## GROUND FLOOR

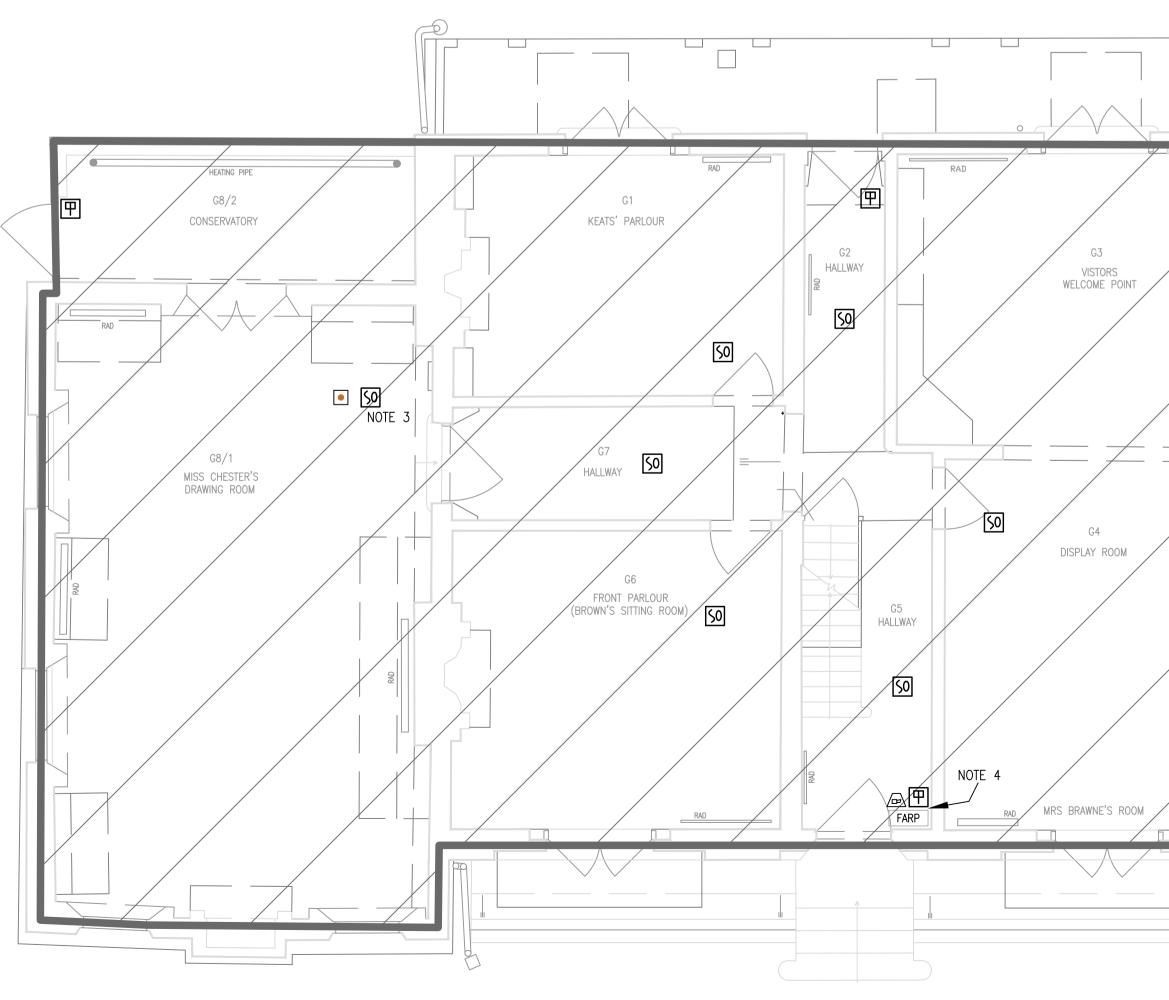
note	S
	1.	SOUNDER HAS MISSING COVER.
, – Sounder	2.	LOCATION OF DNO TP&N SERVICE HEAD & METER ALONG WITH THE HOUSES DISTRIBUTION HEAD.
	3.	IT IS STRONGLY BELIEVED THIS DETECTOR HAS A FAULT IN ITS SUPPLY CABLE AND HENCE DOES NOT WORK.
– MANUAL BREAK GLASS UNIT (REPLACED)	4.	LOCATION OF A SIMPLE INDICATOR PANEL WITH 4 NO. ZONE INDICATORS, A FAULT INDICTOR AND 4 NO. PUSH BUTTONS.
– MAIN FIRE ALARM PANEL (TO BE REMOVED)	5. 6.	SIGNAGE IS UNAFFECTED BY THIS PROPOSAL. WHERE PRACTICAL AND IT DOES NOT IMPAIR ITS OPERATION, ALL NEW &
– FIRE ALARM REPEATER PANEL		EXISTING DEVICES/EQUIPMENT ARE TO BE PAINTED (EVENLY & WITHOUT RUNS) SO AS TO MATCH THE SURROUNDING WALL/CEILING SURFACE TO WHICH IT IS FIXED.
– VISITOR ACCESSIBLE	7.	ALL REDUNDANT CABLING IS TO BE REMOVED AND ANY SURFACES MADE GOOD.
